**Responses to RAI-1, on the ES-3100 Type-B Shipping Container
Docket No. 71-9315, TAC No. L23818**

**Response to RAI # 1
Docket No. 71-9315
TAC No. L23818**

**SAFETY ANALYSIS REPORT,
Y-12 NATIONAL SECURITY COMPLEX,
MODEL ES-3100 PACKAGE WITH BULK HEU CONTENTS**

Figure 2.1.7 - Localized Model of a Stud

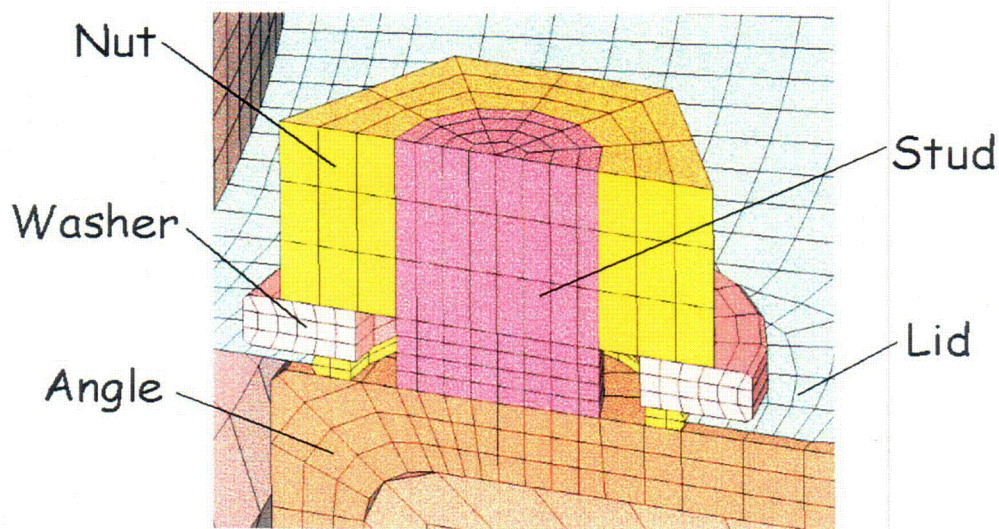
Figure 2.1.7 on page 2-173 of the SAR shows a shell to solid element transition for the drum lid. The load path in this region is from the nut to washer in bearing and from the washer to lid in bearing. Eliminating the bearing surfaces prematurely may have an impact on the stress distribution in this region.

The use of only shell elements to model the lid has been tried in the past. It was found that the contact between the lid and the stud was violated (breaks down) due to the lid nodes passing through the surfaces of the brick elements of the stud when subjected to high shear loadings. The decision was made to not attempt to alleviate this by varying the penalty value of the contact since this would change the contact of other components. The edge on contact of the shell elements with the stud would also be rounded due to the radius of contact and approaches a singular contact point with the stud.

Figure 1 shows an enlarged cross-sectional view of the stud/angle/lid model used on the ES-3100. The centerline of the stud is to the left in the figure. The nut, stud, washer and angle are all modeled with solid elements and their outlines are shown in Fig. 1. The blue colored elements depict the solid elements used in the 3100 lid model and the lid shell elements are modeled at the centerline and are shown by the magenta colored straight line. The purpose of the solid elements at the studs in the lid model is to provide a solid element contact surface with the stud during shear.

Figure 2.3.5.1 - Bounding Kaolite and Average Stiffness Curves

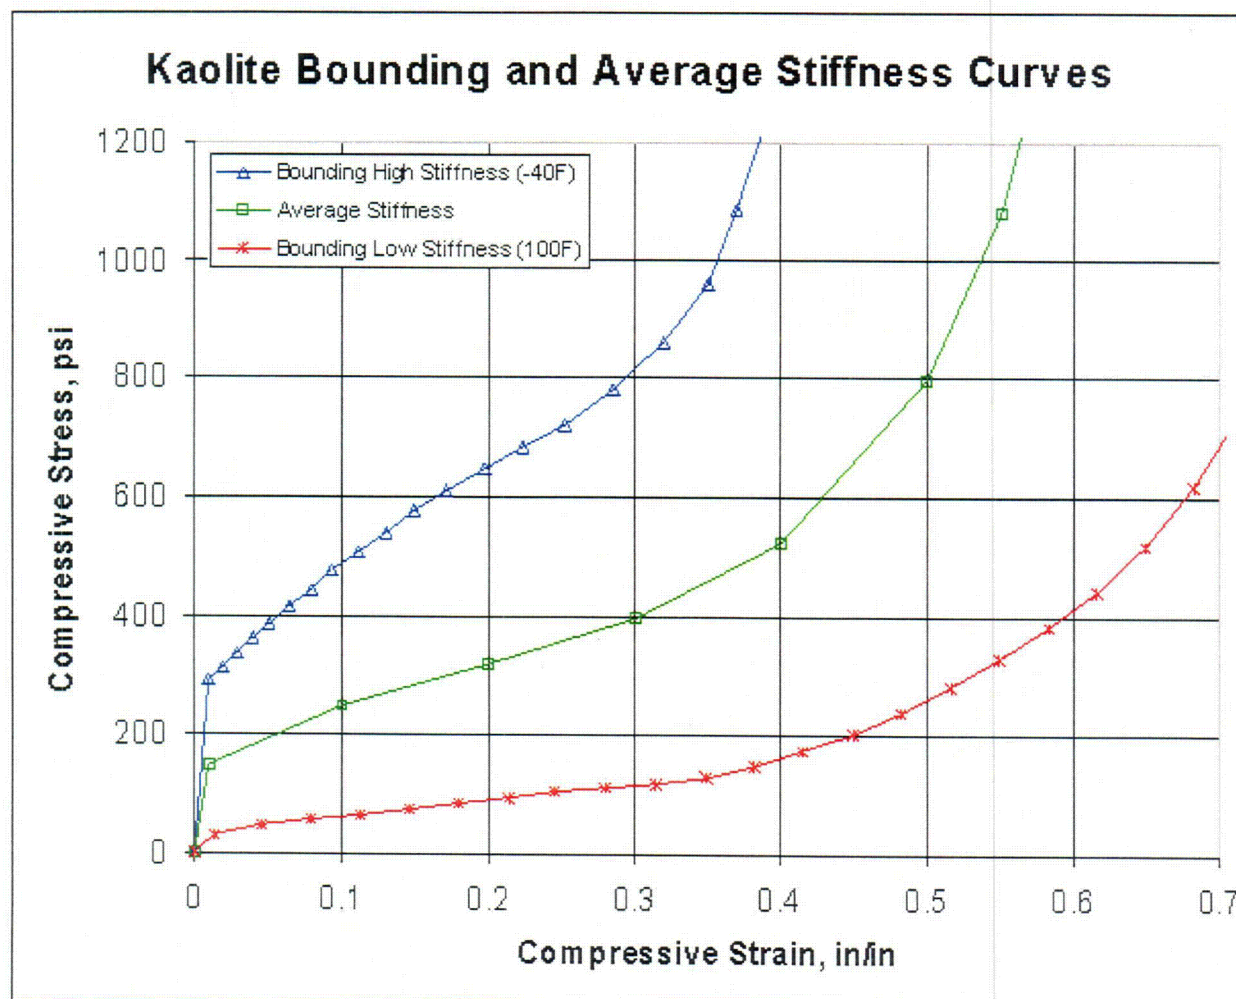
- 2-4 Figure 2.3.5.1 (page 2-186), Table 2.3.5.1.1 (page 2-187), Table 2.3.5.2.1 (page 2-188), and Table 2.3.5.3.1 (page 2-190) reference uniaxial strain. To be consistent with the test report, the text should reflect that constrained Kaolite material data is the same for uniaxial and volumetric strain.

The applicant agrees with the reviewer. For these specimens, volumetric and uniaxial strain data are the same. For clarification in the SAR, the following text will be added after the last sentence in Sect. 2.3.5 on page 2-186:

Fig. 1. Initial configuration of the 12-degree slapdown impact.

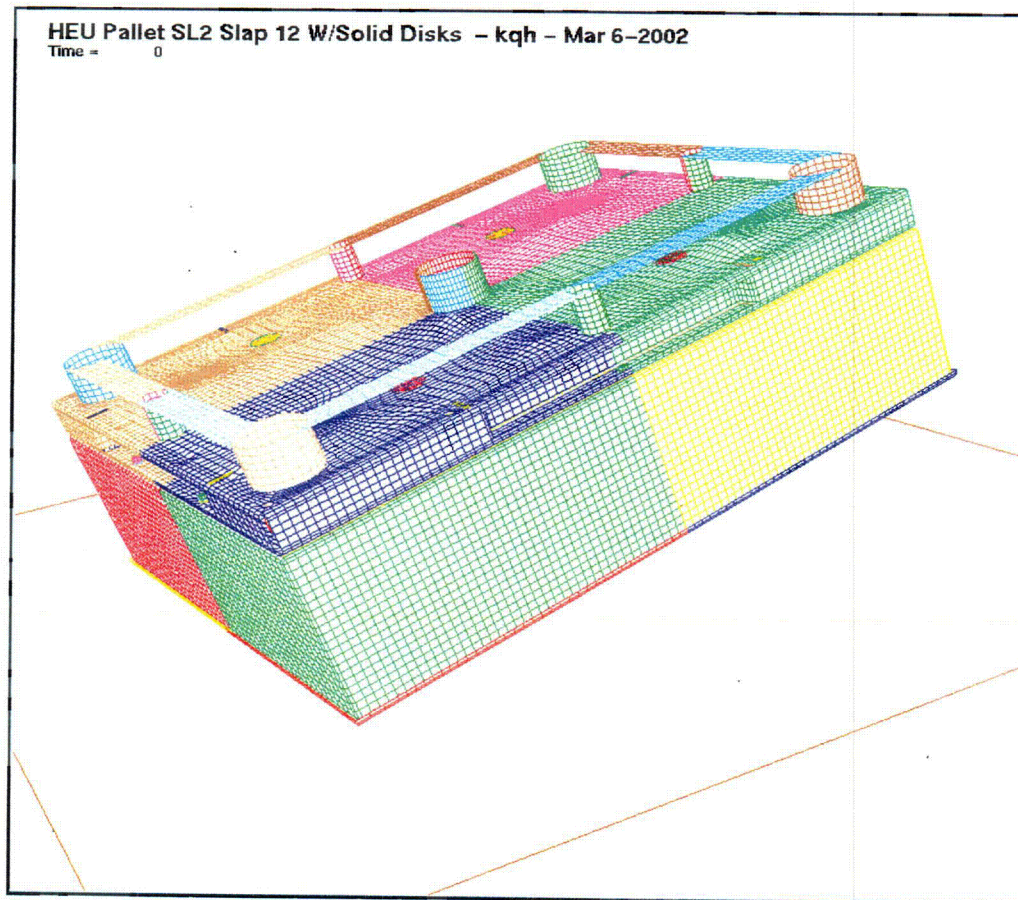
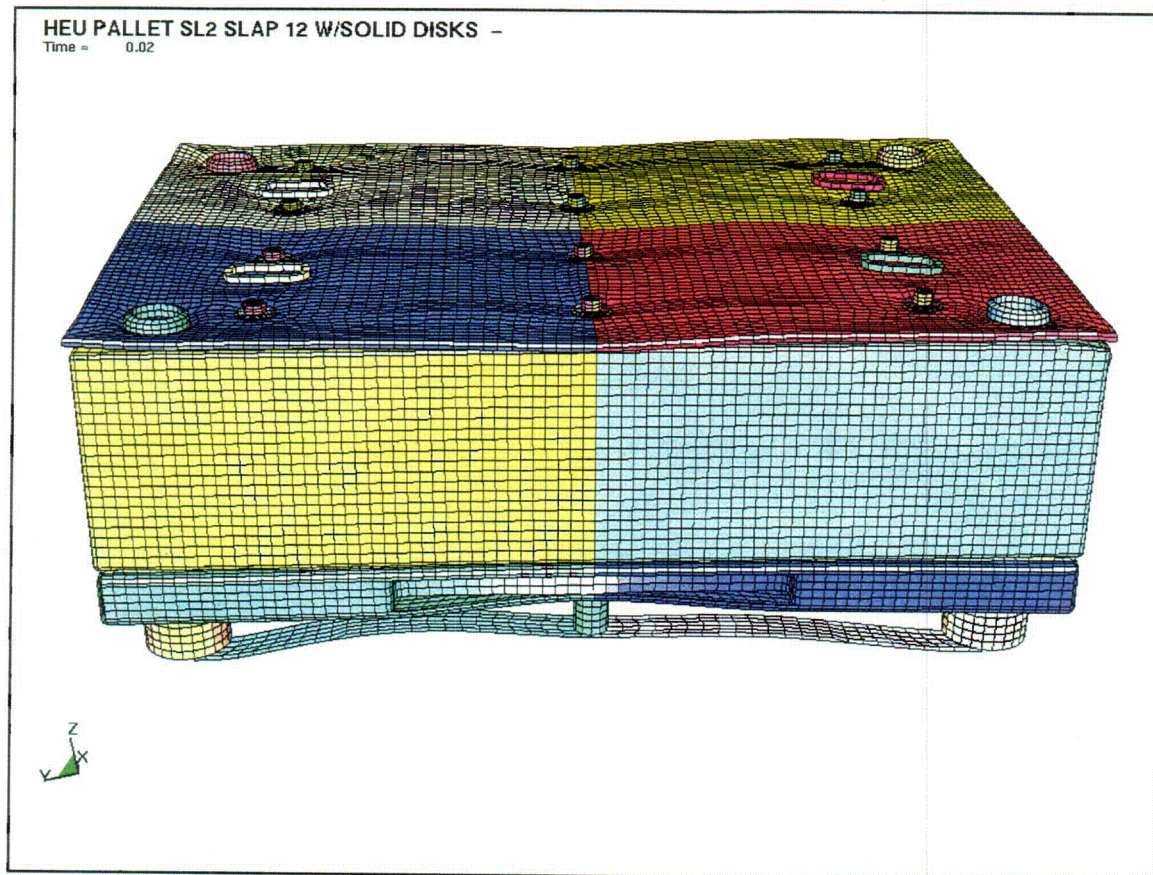
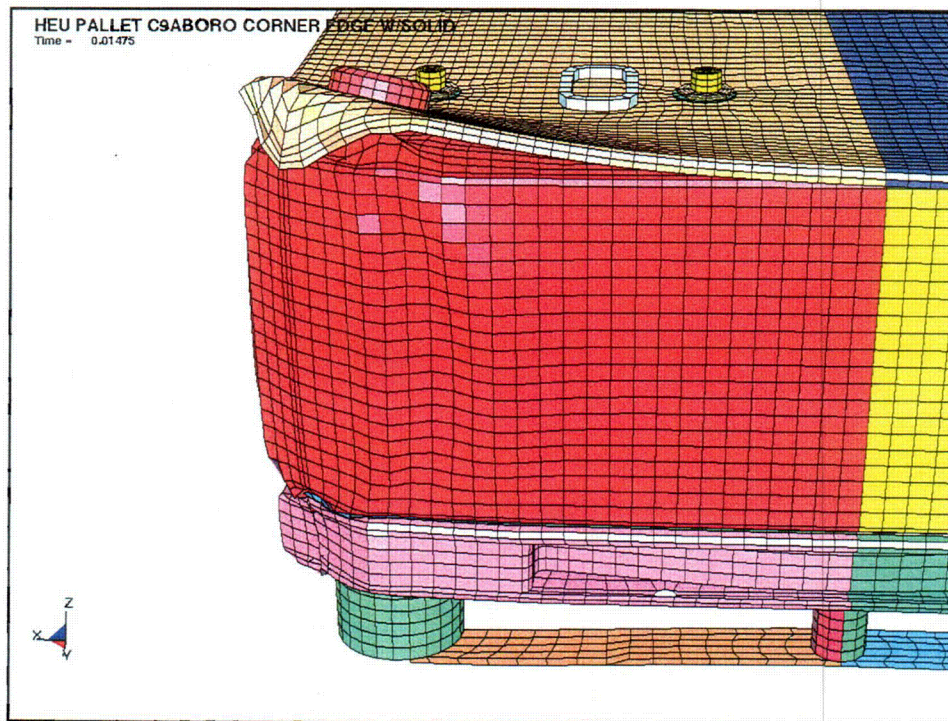
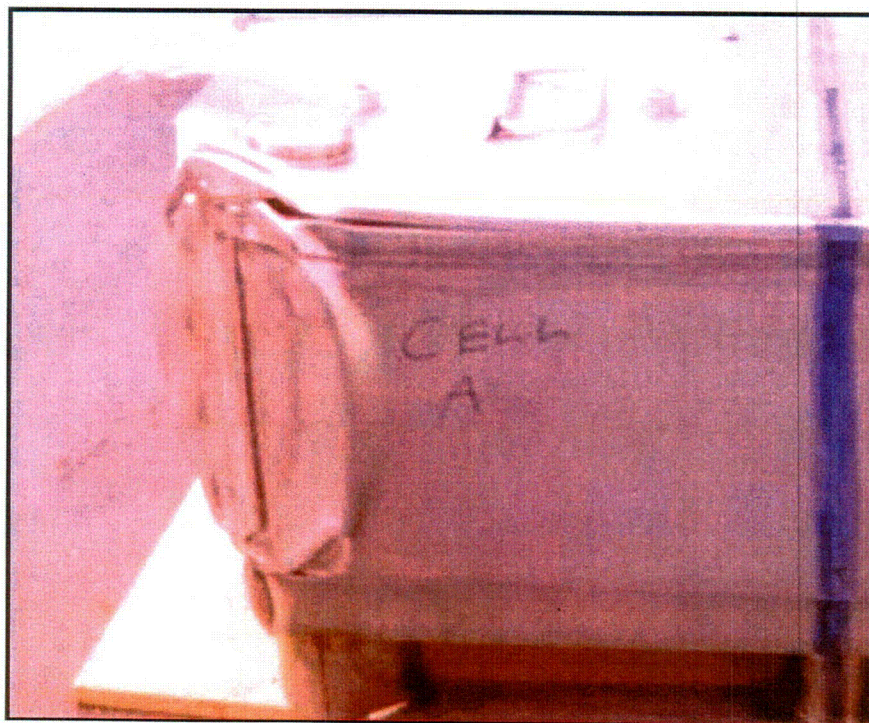
Figure 1 shows an initial view of the RCSB for a 12-degree slapdown onto the lid. The lid of the storage pallet is facing the rigid surface and the bottom forklift region of the pallet is in view. Figures 2 and 3 show the analysis and test results for the slapdown impact. The initially impacting lid edge is shown to the right in Figs. 2 and 3, and the subsequent secondary impacting end is to the left.

Figure 4 shows the initial configuration of the corner edge impact. Figures 5 and 6 show the results for a corner edge impact of the RCSB. Figure 5 shows the analytical results of the corner impact. Figure 6 shows the test final configuration for the corner impact.

No changes to the SAR are suggested in response to this comment.

Fig. 1. Test data volumetric strain vs. pressure.

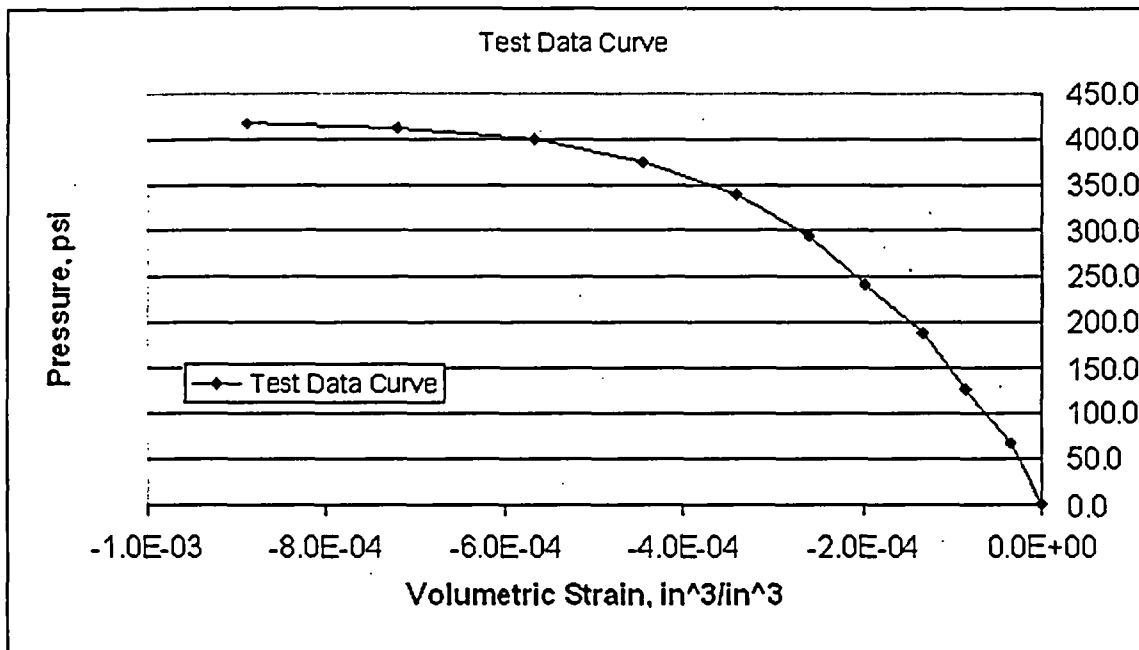
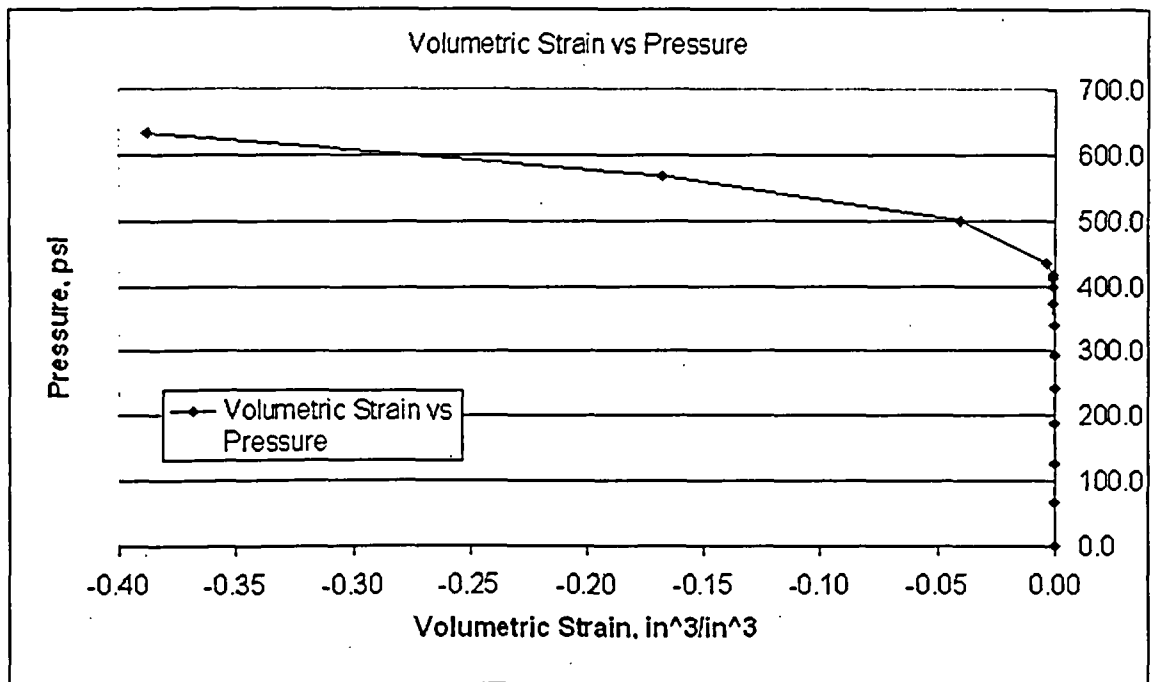
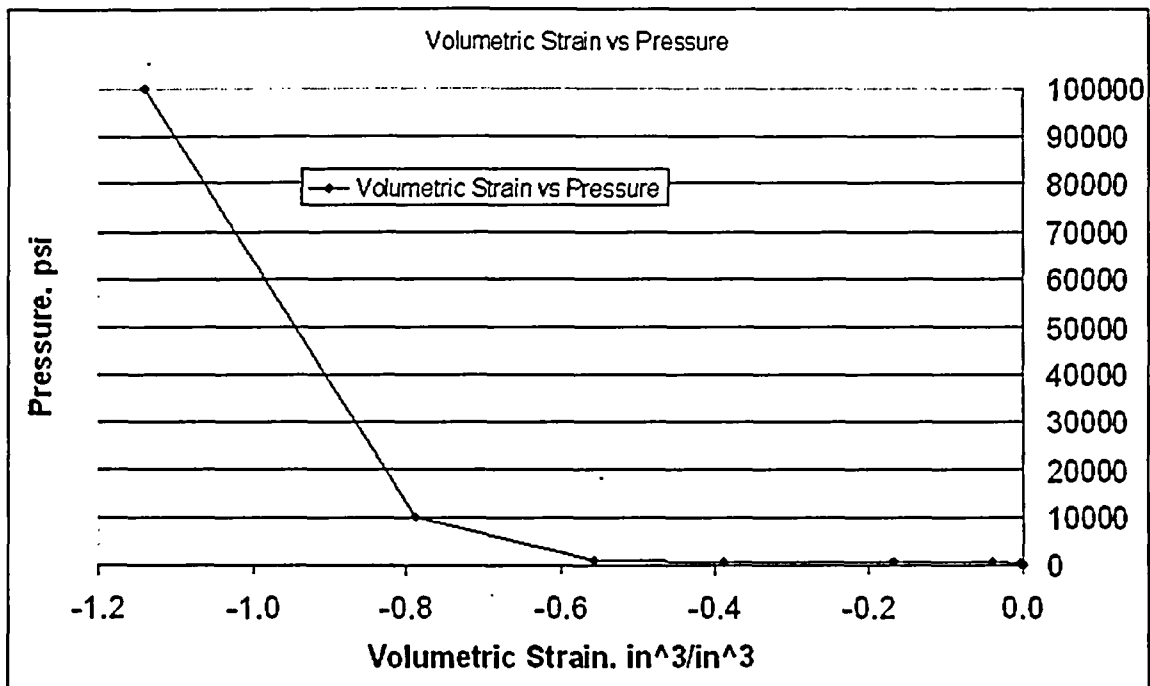
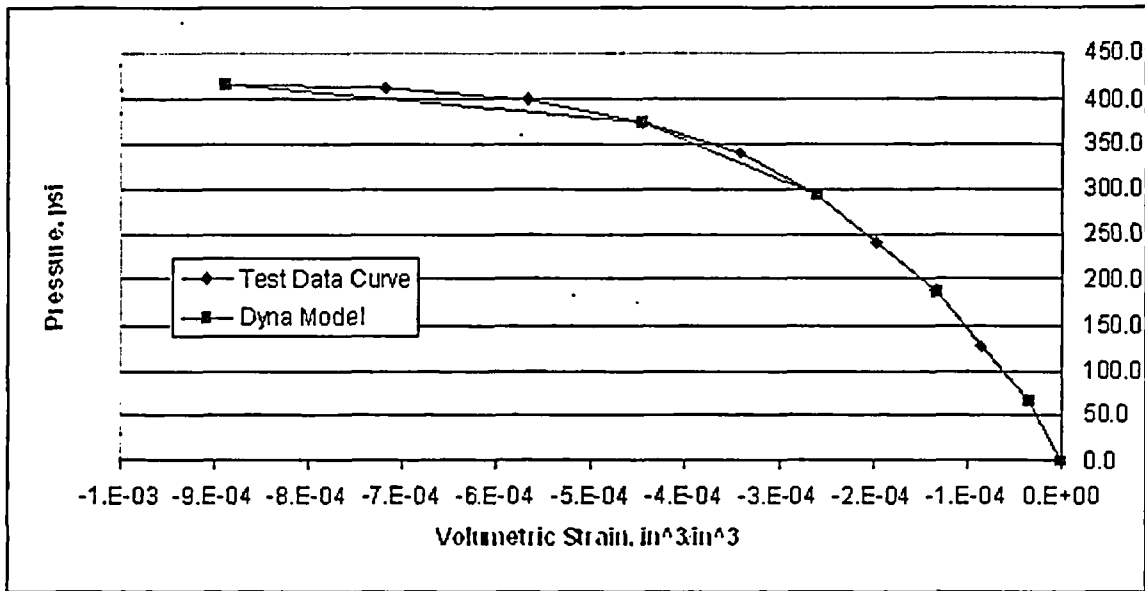
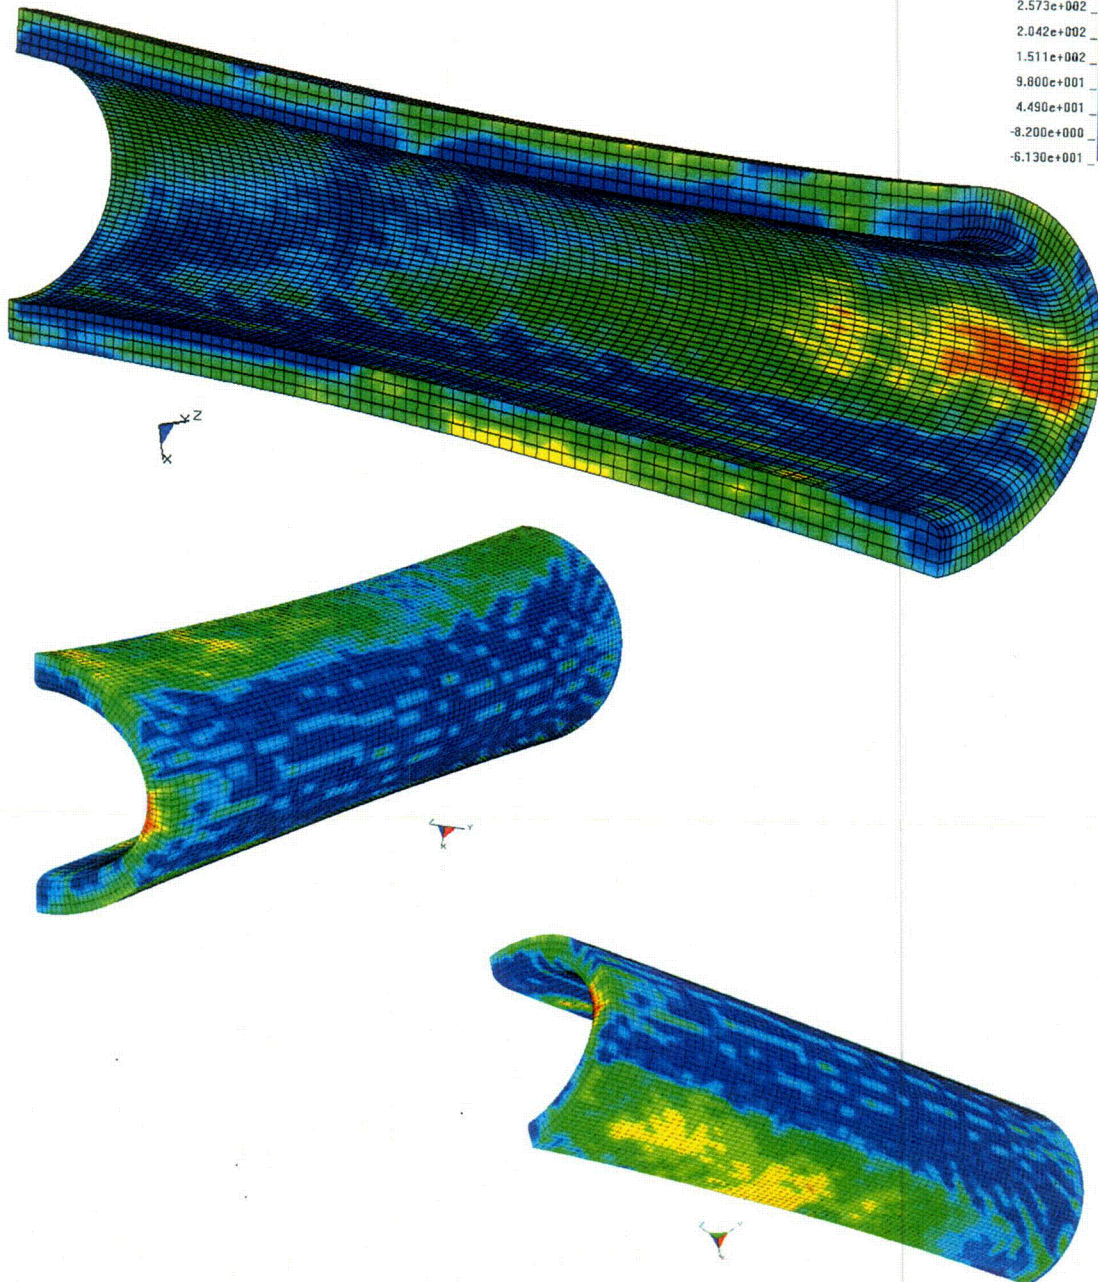
- 2-12 Provide an example calculation and source used to derive the pressure vs. volumetric strain relationship from the uniaxial strain information for Cat 277-4 (HABC). Specifically address how the coefficient, mu (μ) was derived, where mu is the ratio of lateral strain to longitudinal strain.

Experience has shown that most of the demand placed on the energy-absorbing material will be within the test data range (verified below). It is also known that LS-DYNA does not extrapolate a material curve. If the solution reaches an undefined region of the material model, then the solution will become unstable and stop. User-defined material data points must envelop any possible strain that could be experienced in any part of the material during the run. Therefore, a transition from the above data set to a relatively high final data point (knowingly to envelop any possible volumetric strain/pressure demand) is assumed. There is no supporting test data for this region, the points are all chosen to give a relatively smooth curve to the assumed final point.

The following data points were assumed and provide a data point envelope for the analytical run. The data points in Table 3 were chosen (assumed) based on providing a relatively smooth curve to a maximum enveloping value. The value at a strain of 0.8 in./in. was assumed and the other points were chosen to give a smooth transition from the test data to the assumed maximum. The Table 2 test data and the Table 3 assumed data make up the full range of data to be used in the LS-DYNA material model. Due to the extreme range of the data, the Table 2 and Table 3 data are plotted in two ranges. Figure 2 shows volumetric strain between $-0.4 \text{ in}^3/\text{in}^3$ and 0.0 . Figure 3 shows the volumetric strain between $-1.2 \text{ in}^3/\text{in}^3$ and 0.0 .

As a result of this comment, the following SAR changes will be made:

The "μ" (mu) used in four places on page 2-367 of the SAR will be changed to the correct symbol "ν" (nu).
